STORMWATER MANAGEMENT PLAN
FOR CREEKSIDE SOUTH AT LORSON RANCH

PUDSP 20-xxx

CREEKSIDE SOUTH AT LORSON RANCH
FULL SPECTRUM POND E2
OUTLET STRUCTURE MODIFICATIONS

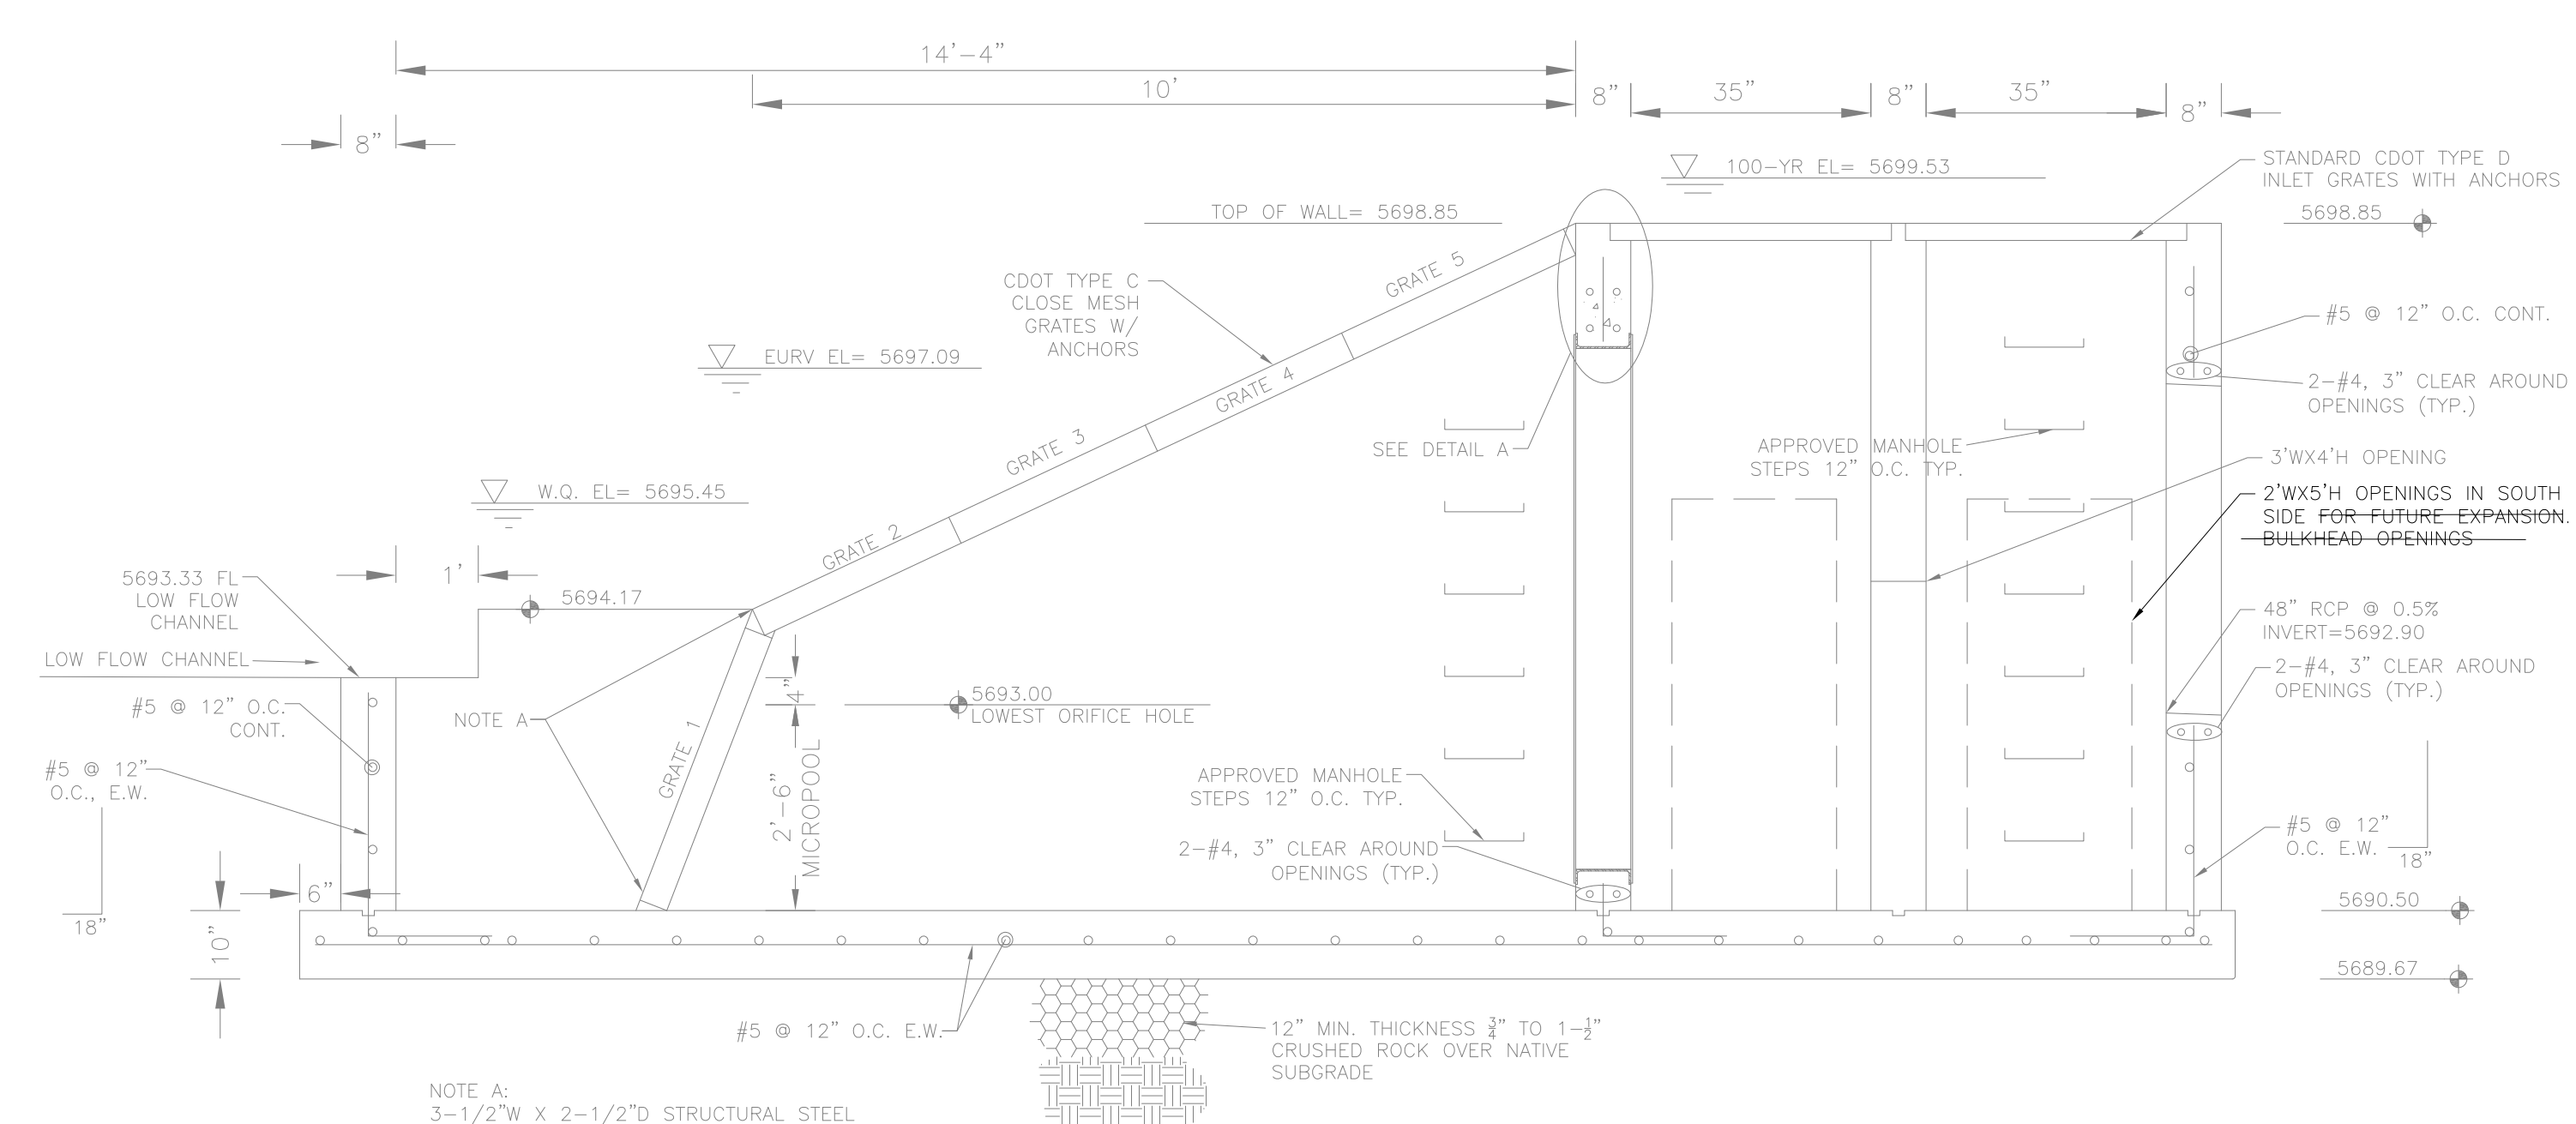
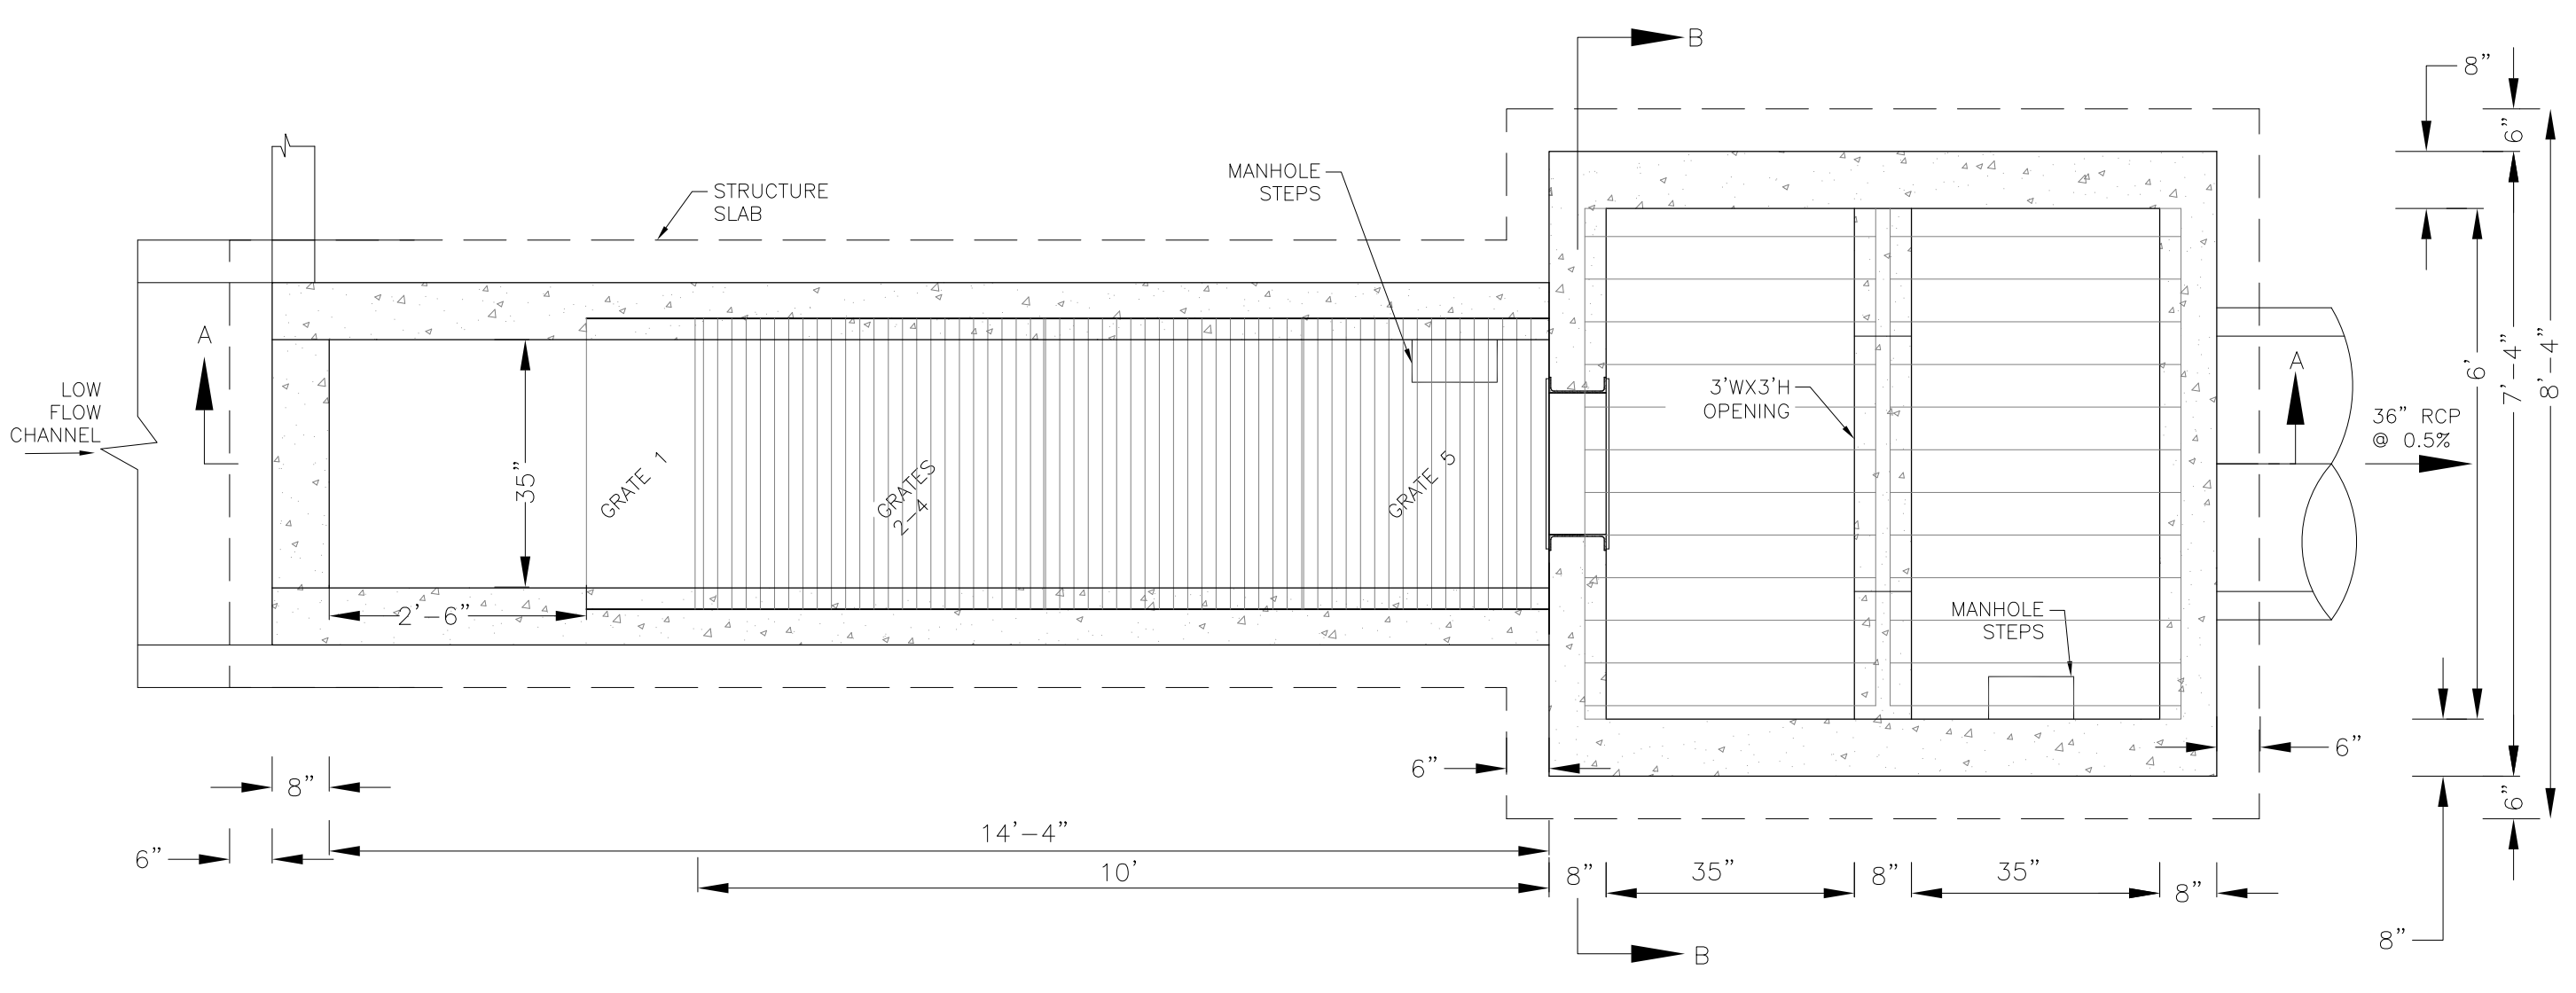
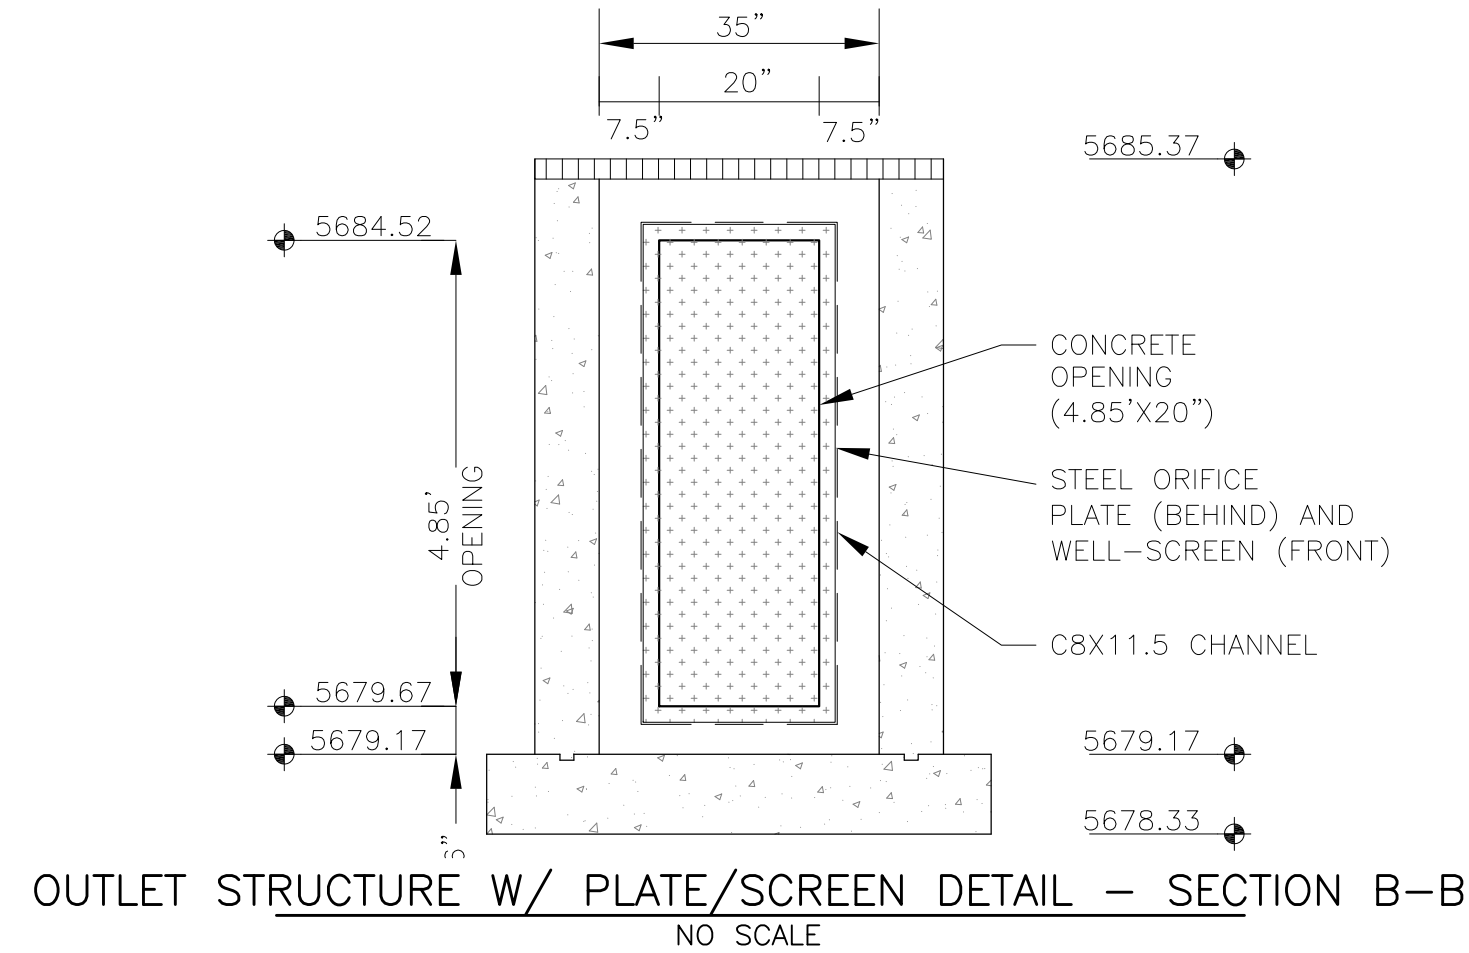
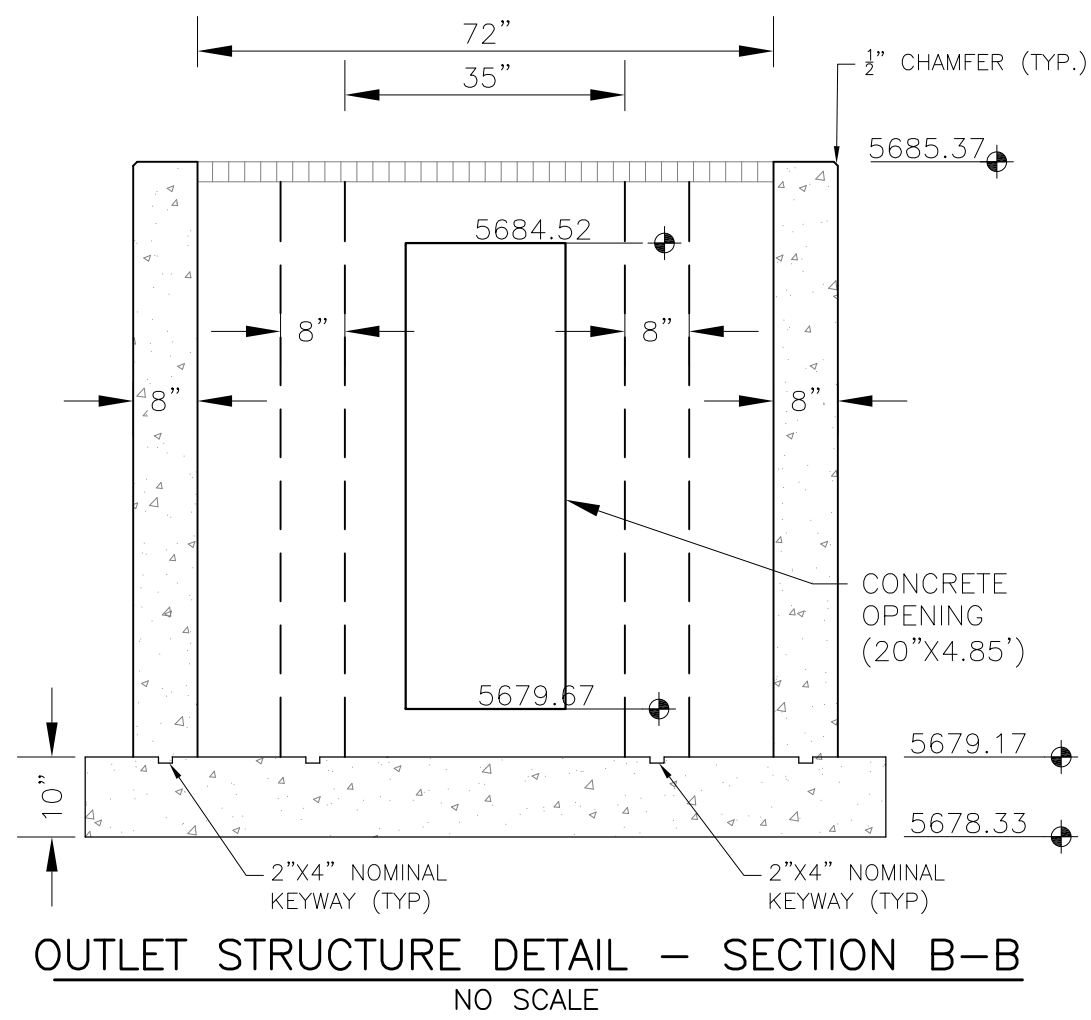
CONSTRUCT
THIS OPENING FOR
CREEKSIDE SOUTH!!!!!!

CONSTRUCT
THESE HOLES FOR
CREEKSIDE SOUTH!!!!!!

DO NOT
CONSTRUCT
SMALLER
HOLES!!!!!!
